Model: Model AL-P1		Date: 28-Apr-08	No.: MG179001
Modified Article: FAN		Prepared by: K. Hamada	
From: 2nd Tech. Support Sec. Service Support Dept.			
Reason for Modification:	☐ Parts catalog correction ☐ Vendor change ☐ Other ☐ To facilitate assembly ☒ To improve reliability ☐ To meet standards ☐ Part standardization ☐ Product Safety ()

Part Change Information List

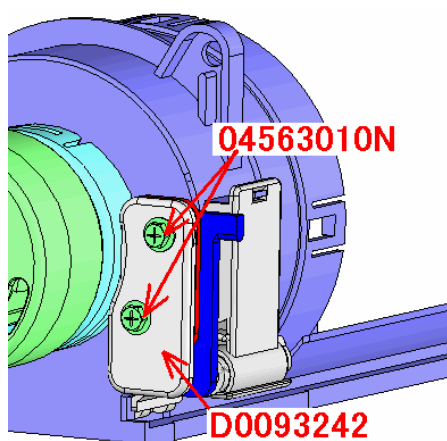
Change/Reason: These parts were deleted (Parts Catalog error).

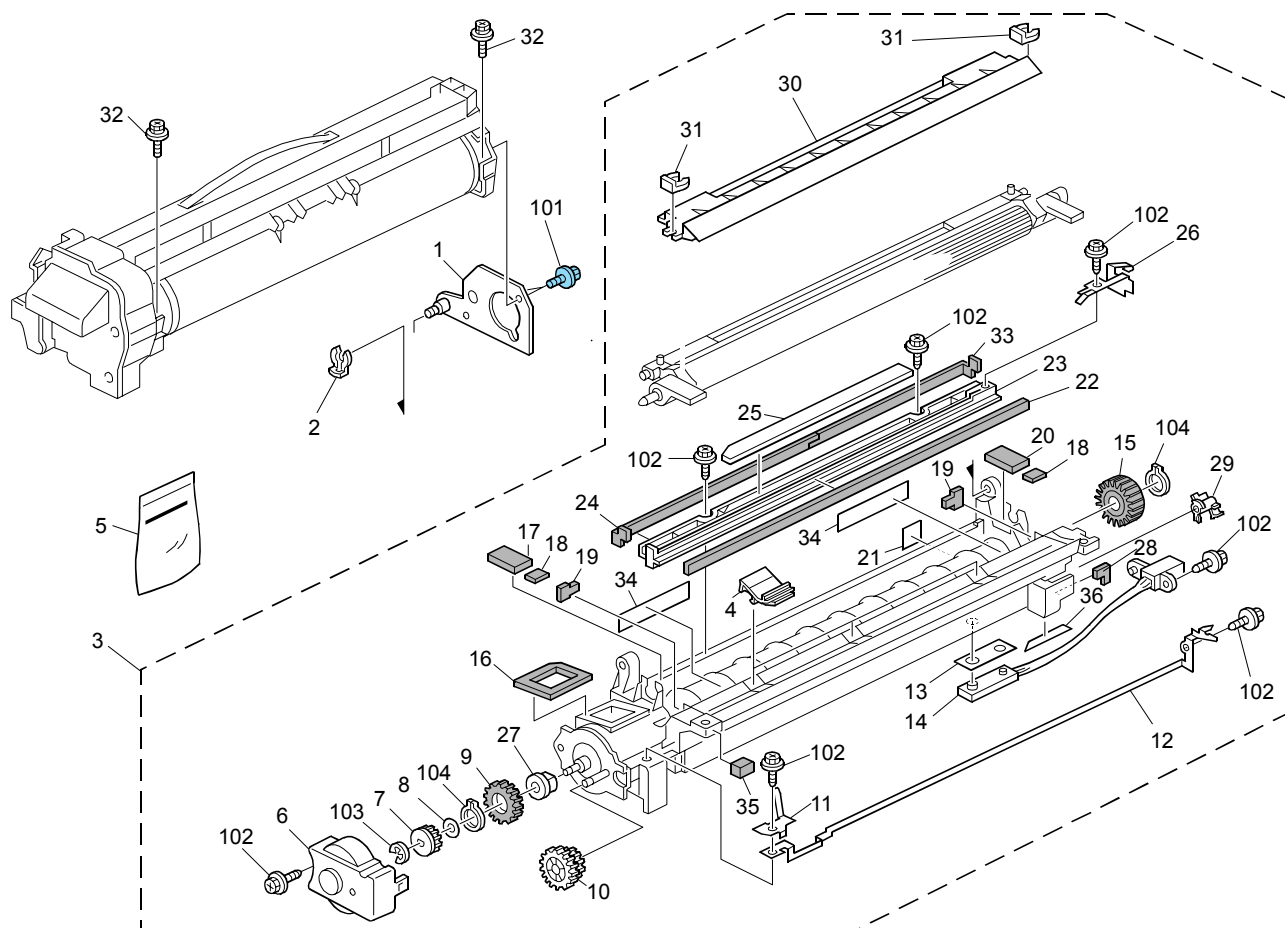
Change: The surface treatment for the development roller was changed.

Reason: To further ensure that toner cannot stick to the development sleeve.
